Access Compliance Report

Public Rights-of-Way

Intersection ID: 2625	Main Street: KILMARTIN_LN	Cross Street: TULLAMORE_LN	Location:	S
ADA ID: 7A2BFC0E1009	Ramp Type: BlendTrans1	Initial Pass/Fail: Fail	Overall Compliance: No	Severity Score: 10

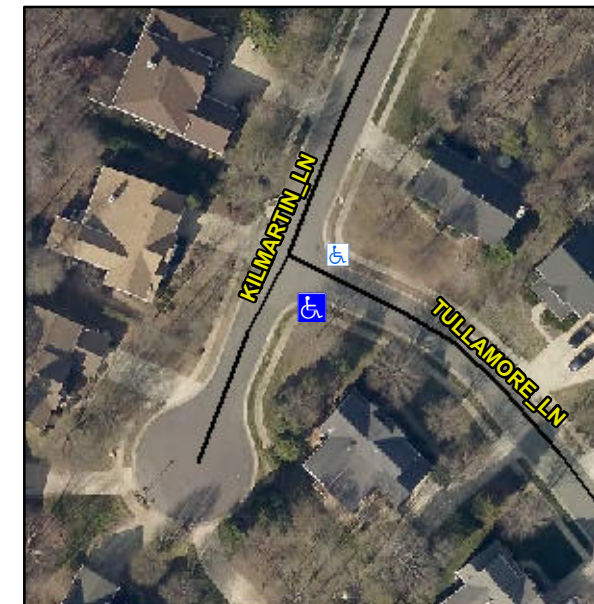
Not Found, R304.5.1, R304.5.3

Compliance	Description	Data	Compliance	Description	Data
N/A	Ramp Length (in)	46.0	Yes	BlendTrans Slope (%)	2.8
No	Ramp Width (in)	47.0	No	BlendTrans XSlope (%)	2.6
N/A	Flare Type LT	N/A	N/A	Flare Type RT	N/A
N/A	Flare Slope LT (%)	N/A	N/A	Flare Slope RT (%)	N/A
N/A	Flare Traversable LT?	N/A	N/A	Flare Traversable RT?	N/A
N/A	Landing Length (in)	N/A	N/A	DWS Provided?	N/A
N/A	Landing Width (in)	N/A	N/A	DWS Contrast?	N/A
N/A	Landing Slope (%)	N/A	N/A	DWS Length (in)	N/A
N/A	Landing X Slope (%)	N/A	N/A	DWS Full Width?	N/A
N/A	Landing Curb? (Y/N)	N/A	N/A	DWS Offset (in)	N/A
N/A	Shared Landing?	N/A			
N/A	Gutter Ponding?	N/A	N/A	Gutter Slope (%)	N/A
N/A	Gutter Lip Ht (in)	N/A	N/A	Gutter X Slope (%)	N/A
N/A	Painted X Walk1?	No	N/A	Painted X Walk2?	N/A
	X Walk 1 Direction	To NE		X Walk 2 Direction	N/A
	X Walk 1 Width (in)	N/A		X Walk 2 Width (in)	N/A
	X Walk 1 Slope (%)	1.1		X Walk 2 Slope (%)	N/A
	X Walk 1 X Slope (%)	0.9		X Walk 2 X Slope (%)	N/A

N/A	Ramp inside XWalk1?	N/A	N/A	Ramp inside XWalk2?	N/A
	Road Slope (%)	0.9		Clear Space?	N/A
	Road X Slope (%)	1.1	N/A	Clear Space to XWalk (in)	N/A
N/A	Any Obstructions?	N/A	N/A	Storm Grate/Utility Hazard?	N/A
	Obstruction Type			Storm Grate/Utility Type	
		N/A			N/A
			Yes	Surface Condition? (G/P)	Good
			No	Curb Slope (%)	16.7

Remove & Replace Curb Ramp With Two New Directional Ramps or Equivalent.
